INDEPENDENT ORBITER ASSESSMENT

ASSESSMENT
OF THE
BACK-UP
FLIGHT
SYSTEM

WORKING PAPER NO. 1.0-WP-VA88003-17

INDEPENDENT ORBITER ASSESSMENT
ASSESSMENT OF THE BACKUP FLIGHT SYSTEM FMEA/CIL

Figure 1 - BFS FMEA/CIL ASSESSMENT

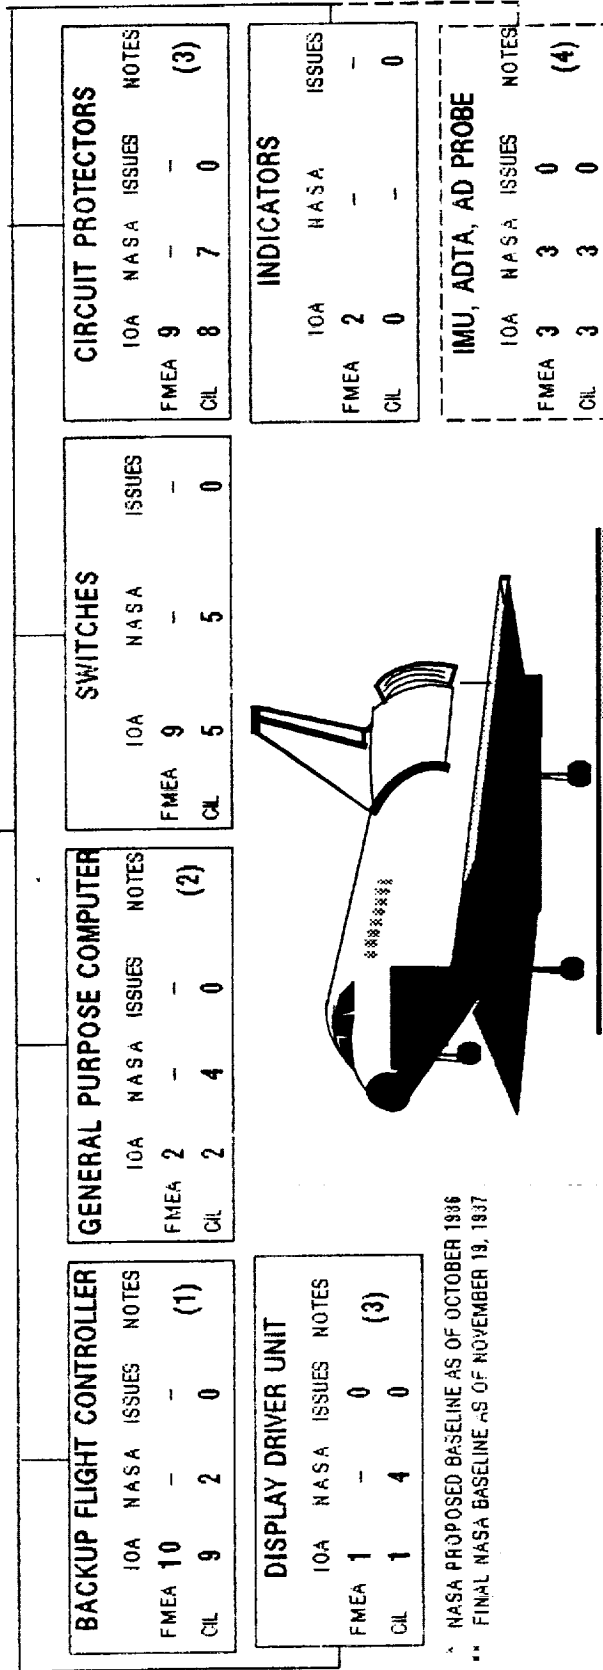
The original assessment determined there were numerous failure modes and potential critical items in the IOA analysis that were not contained in the NASA BFS baseline. Conversely, the NASA baseline contained three FMEAs (IMU, ADTA, and Air Data Probe) for CIL items that were not identified in the IOA product. The IOA prepared worksheets and agreed with the NASA analysis for the three items. This increased the IOA worksheets from 29 to 32 and the PCIs from 21 to 24 for the original assessment as shown in Figure 1.

failures. This increased the IOA worksheets from 32 to 33 and the PCIs from 24 to 25 for the final assessment. The IOA assessment of the final updated baseline (Nov. 19, 1987) results in agreement on all BFS CIL items even though there are differences in number of items and assigned criticalities. Figure 1 presents an overview of the assessment results.
